TECHNICAL BULLETIN

No. 212-99-183

MODEL AFFECTED: 212

SUBJECT: FORWARD CROSSTUBE, MODIFICATION OF

FIGURE 1

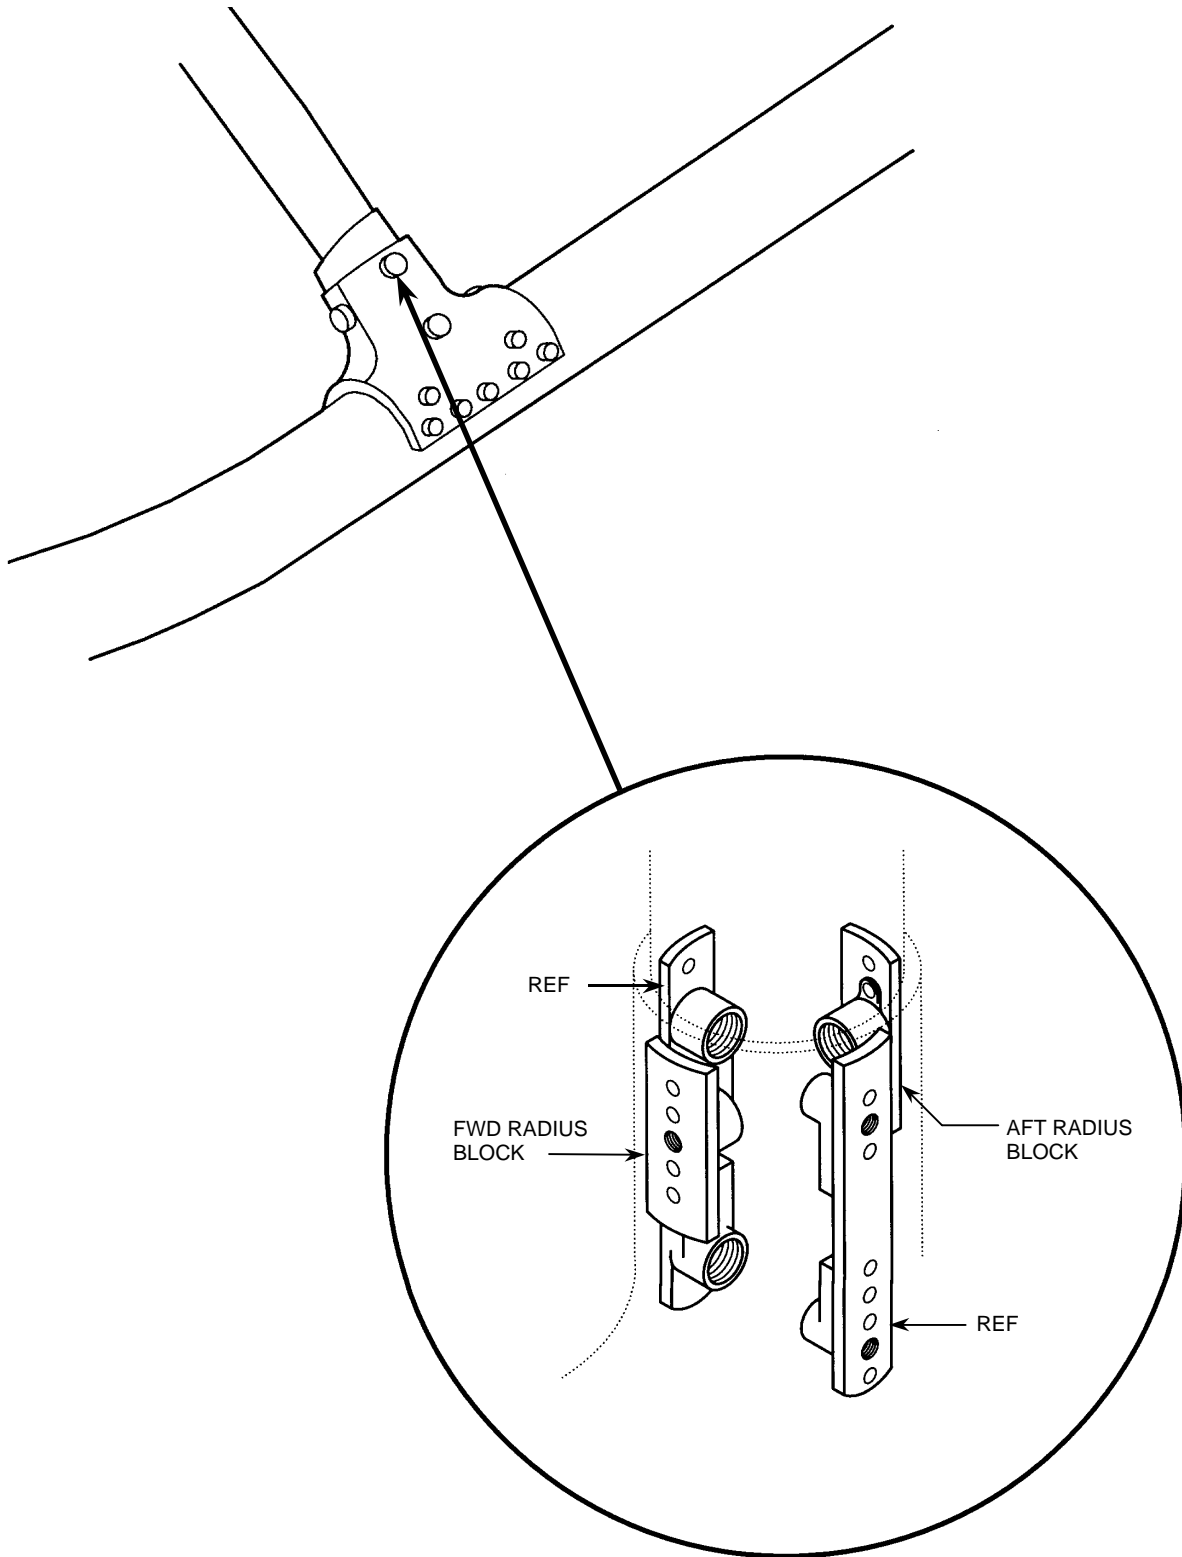
This bulletin introduces modifications required to permit the use of the one-piece forged saddles with the original (P/N 205-050-400-013, /-039, /-055) style of forward crosstubes. The one-piece forged saddles require larger fasteners in the fore and aft crosstube attaching positions than the original two-piece sheet metal style.

1. Remove and disassemble landing gear from helicopter as per maintenance manual to accomplish the forward crosstube modification.
2. Remove the forward and aft radius block assemblies P/N 90-019-2 via drilling off attaching rivets on the forward crosstube (ref. Figure 1).

3. Remove nutplates P/N MS21069L4 from the radius blocks assembly P/N 90-019-2.
4. Fill holes in radius block with P/N MS 20426AD3 rivets (double flush).
5. Enlarge the 0.264/0.270 inch holes in the 90-019-2 radius blocks to 0.403/0.410 inch.

6. Install new MS21069L6 nutplates with MS20426AD4 rivets in the previously reworked radius block. Radius blocks are now reworked to the 90-019-1 configuration.
7. Enlarge the two 0.265/0.272 inch diameter bolt holes in the fore and aft positions of the crosstube cuff to 0.385 / 0.392 inch.
8. Install 90-019-1 radius block assemblies in the fore and aft positions of the forward crosstube using P/N MS20426AD3 rivets.
